## Addendum

**No.** 01  
**Date:** 01-24-2025  
**Project:** Clackamas Fire District Training Warehouse  
**Architect:** Scott Edwards Architecture, LLP  
 2525 E. Burnside Street  
 Portland, Oregon 97214  
 Phone: (503) 226-3617  
 Fax: (503) 226-3715

Incorporate the following clarifications, revisions, additions and/or corrections into the bid documents for the above referenced project:

# G0.01

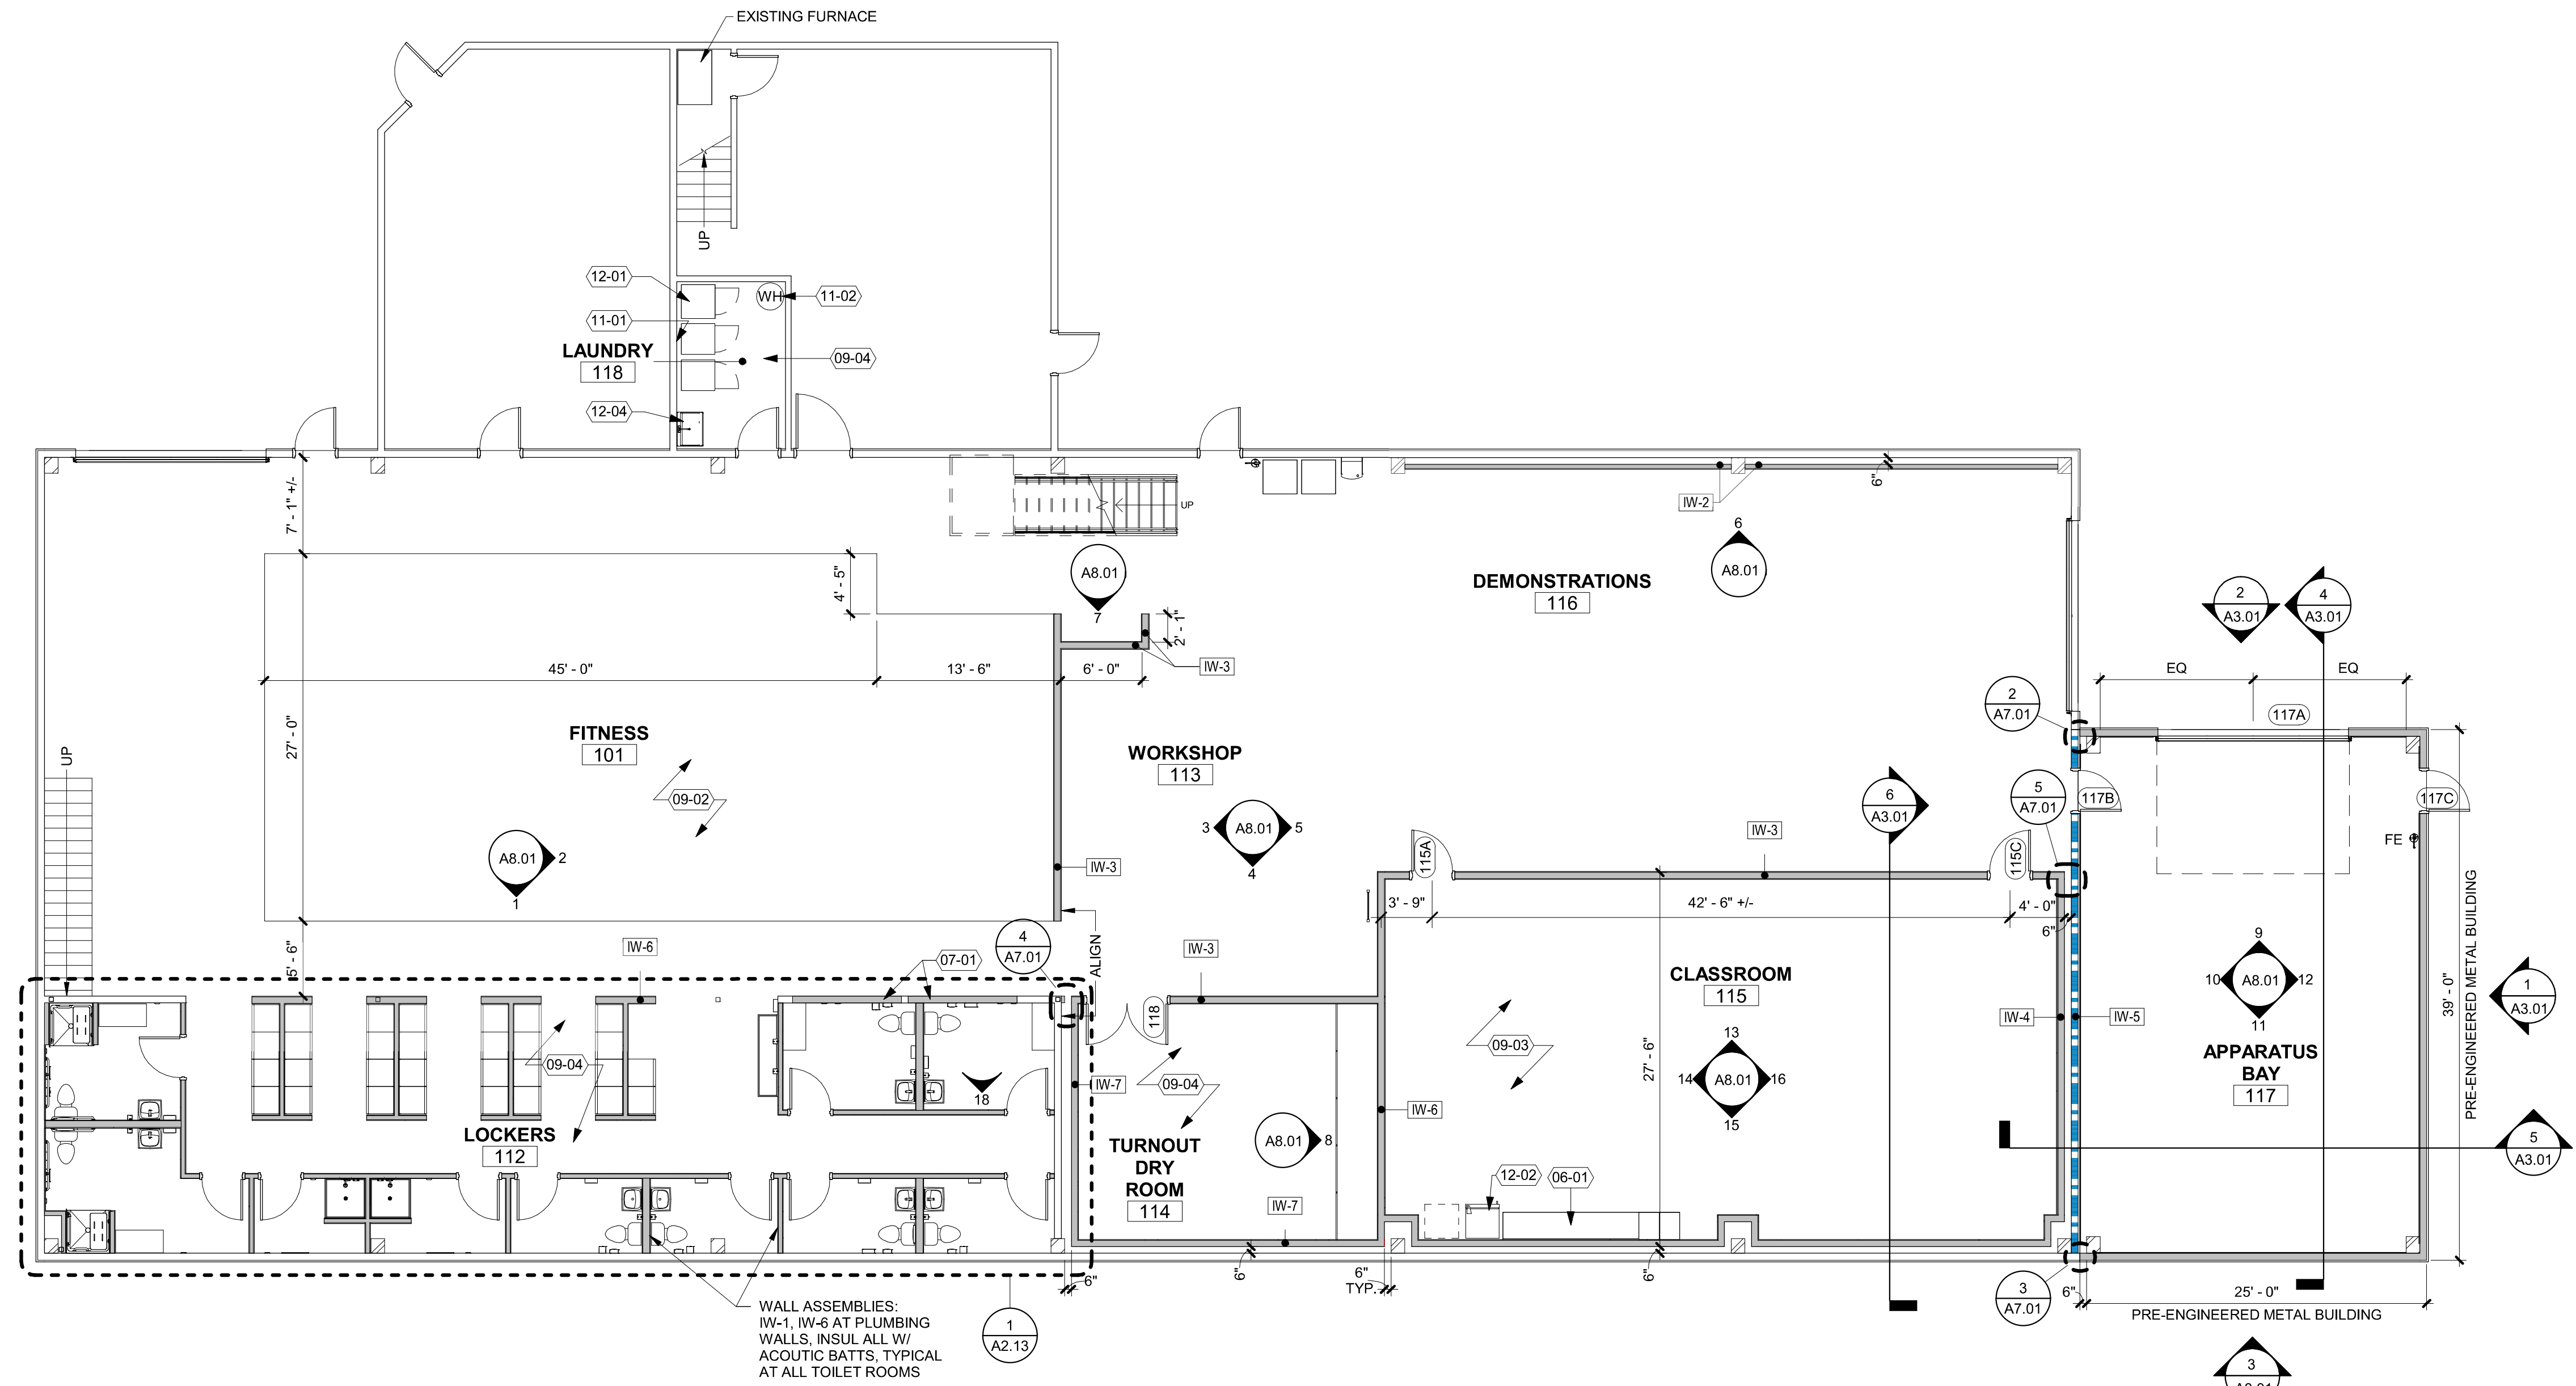
Sheet G0.01	<ol style="list-style-type: none"> <li>1. Deductive Bid Alternates #1 added identifying the PEMP addition, in its entirety, as a deductive alternate.</li> <li>2. Delegated / Bidder Design Items list modified adding #8, Handrails and guardrails and their attachments.</li> <li>3. Deferred Submittal list modified adding #8; COMcheck lighting compliance Report and #9; Guardrail and handrail design and connections.</li> </ol>

**2 MEZZANINE FLOOR PLAN**  
 1/8" = 1'-0"

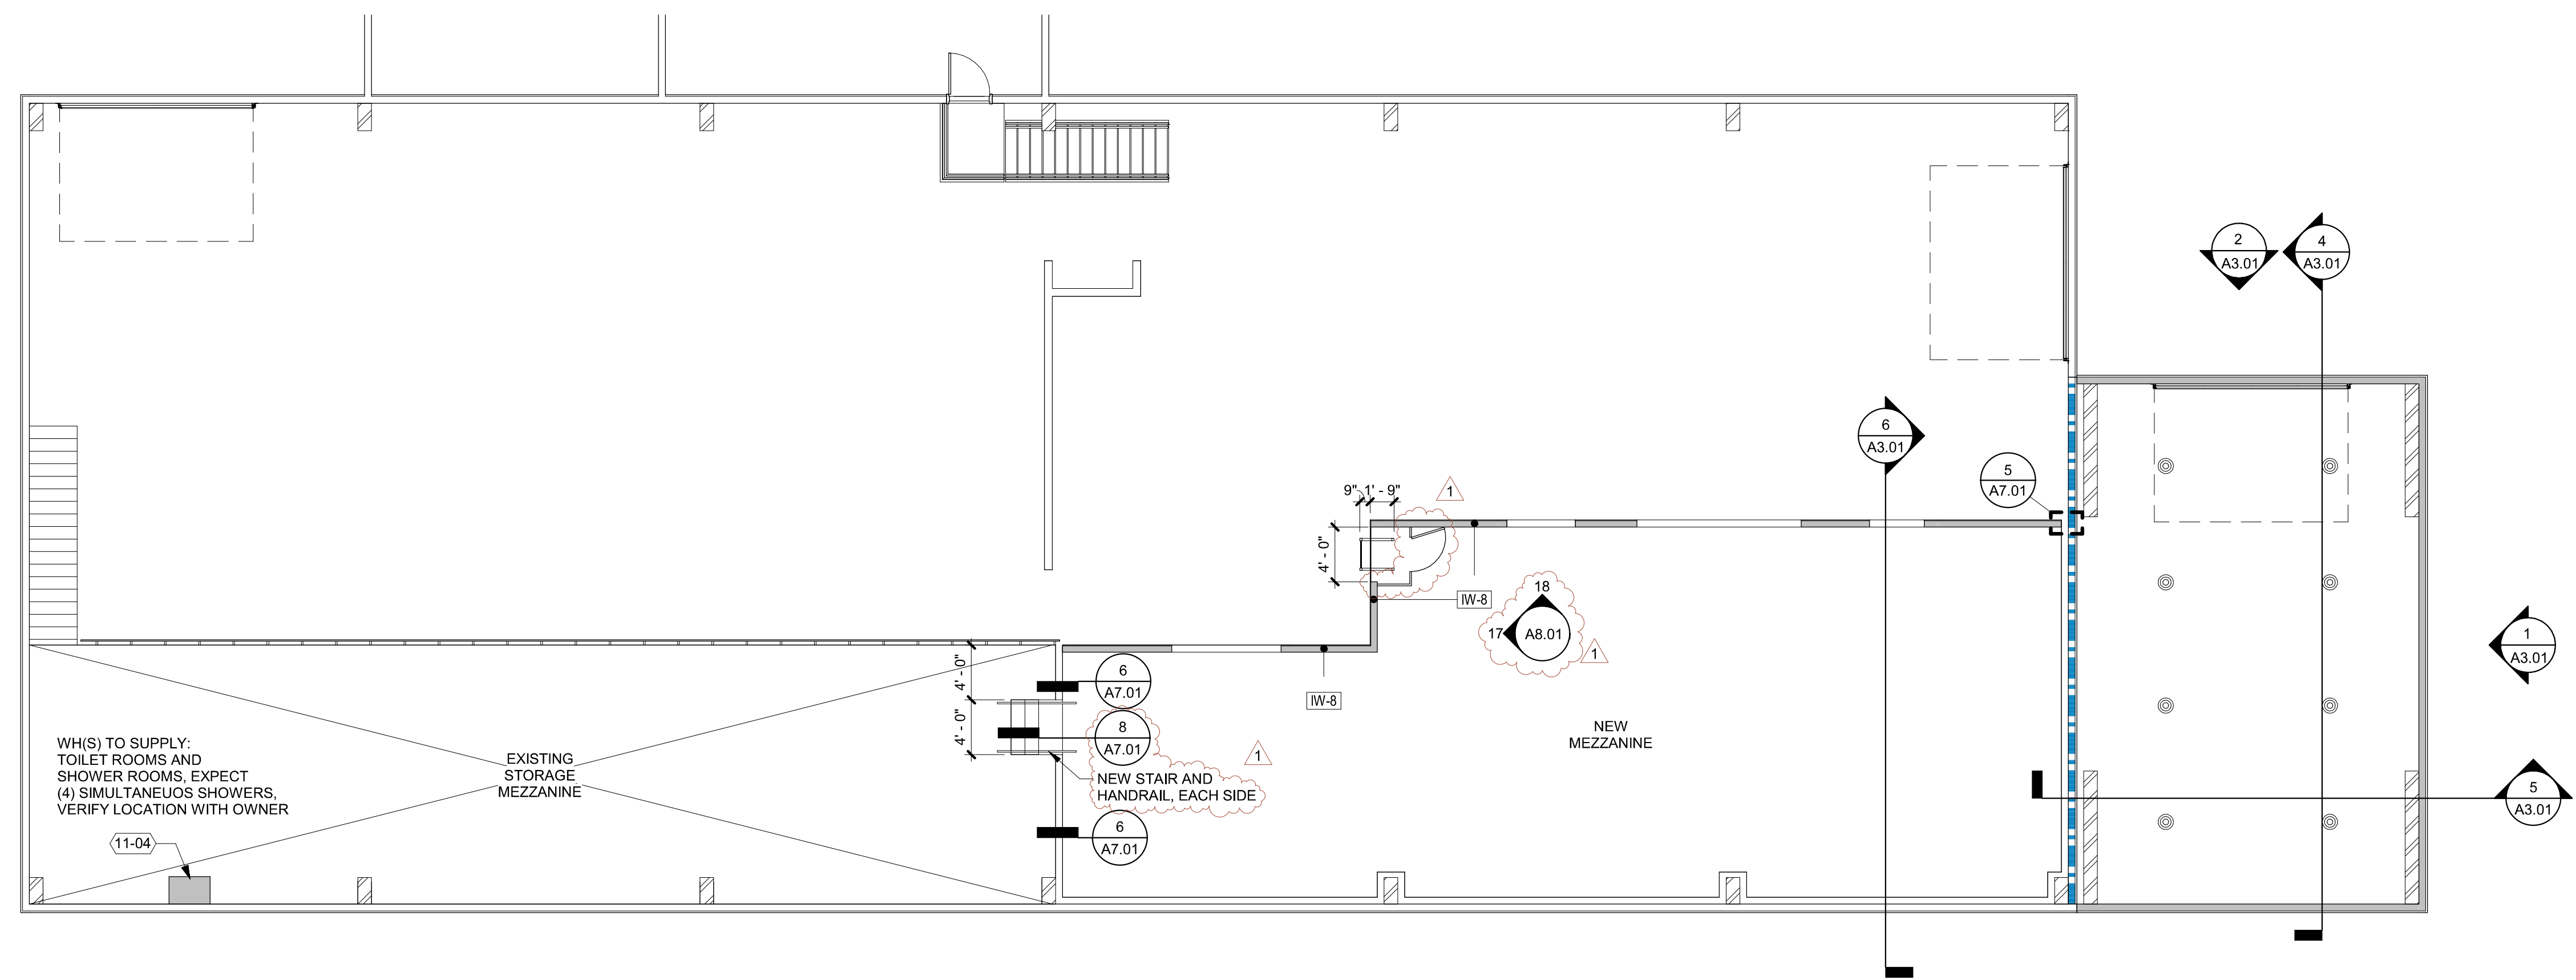
Sheet A2.12	<ol style="list-style-type: none"> <li>1. Drawing 2 – Mezzanine Floor Plan; Added handrails to each side of new stair, detail revised.</li> <li>2. Drawing 2 – Mezzanine Floor Plan; Added guardrail and gate at the new ladder, added interior elevations of the guardrail.</li> </ol>

**8 STAIR SECTION**

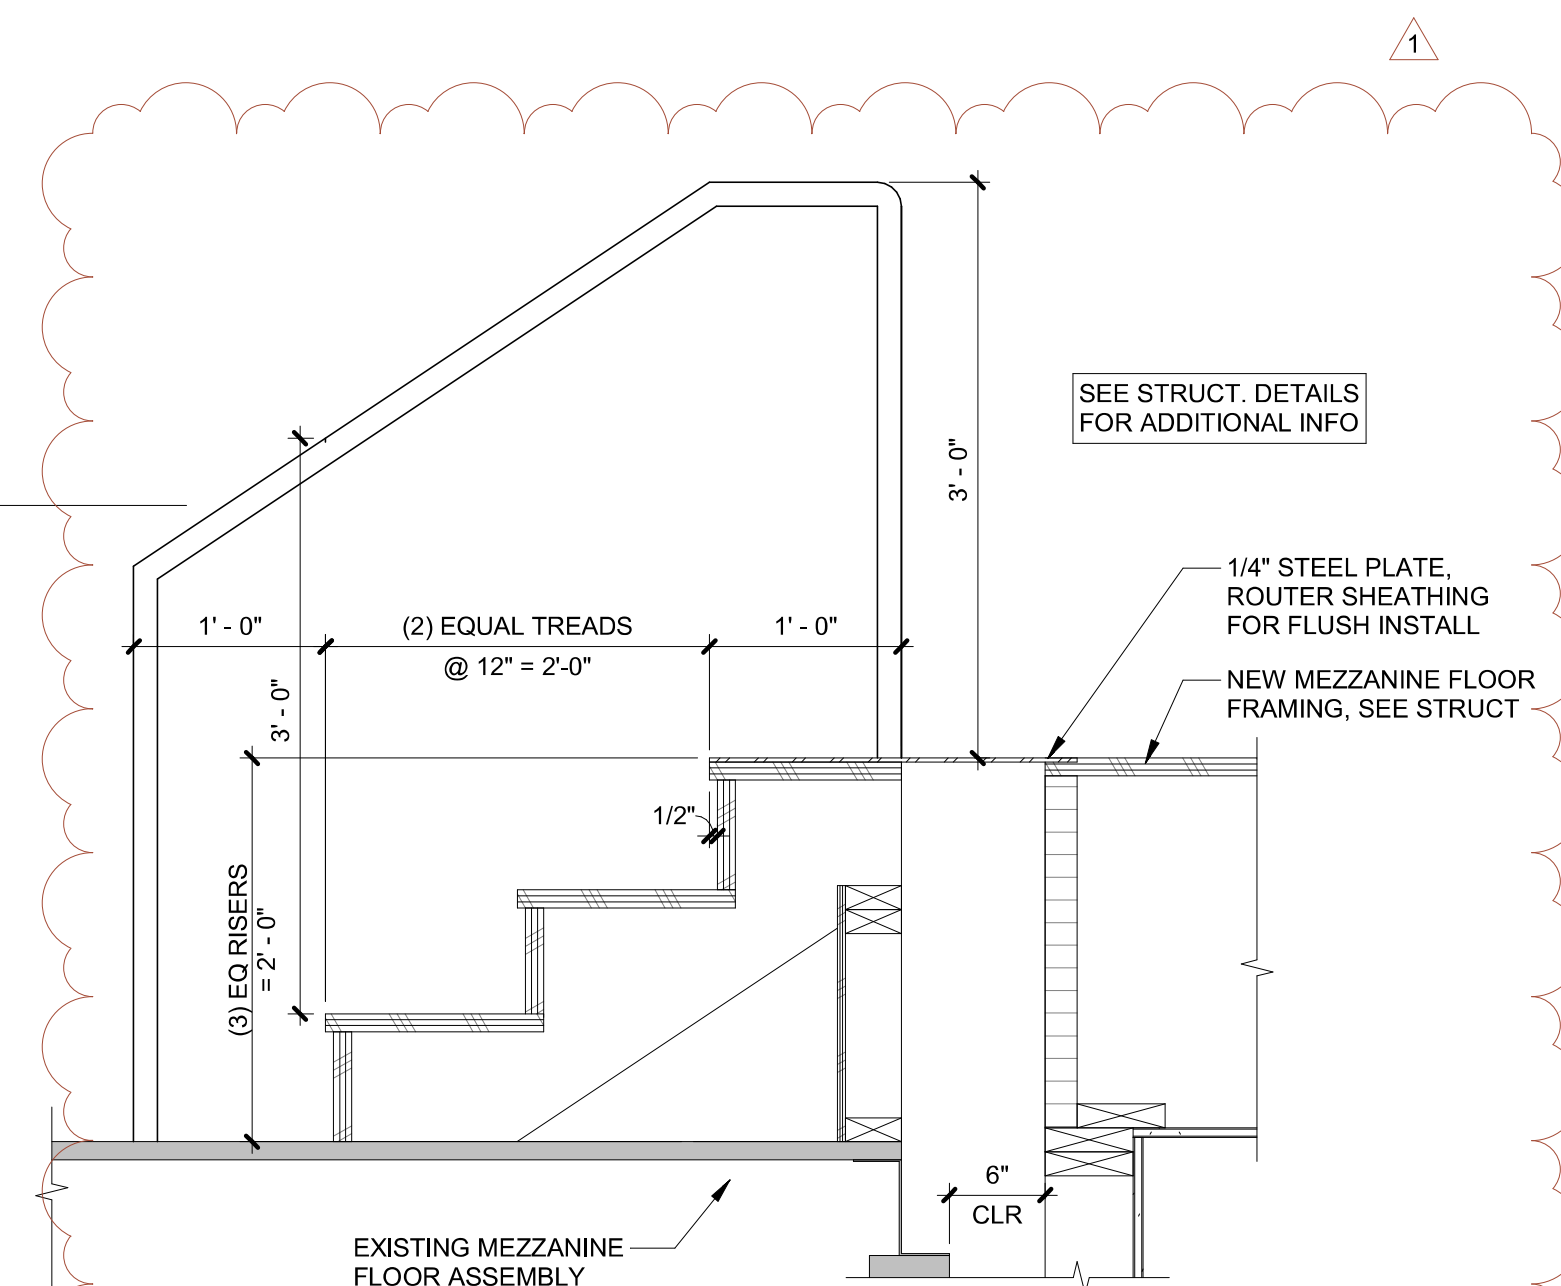
Sheet A7.01	<ol style="list-style-type: none"> <li>1. Detail 8 revised to show handrail scope of work</li> </ol>
Sheet A8.01	<ol style="list-style-type: none"> <li>1. Interior Elevations 17 &amp; 18 added showing Guardrail scope of work.</li> </ol>
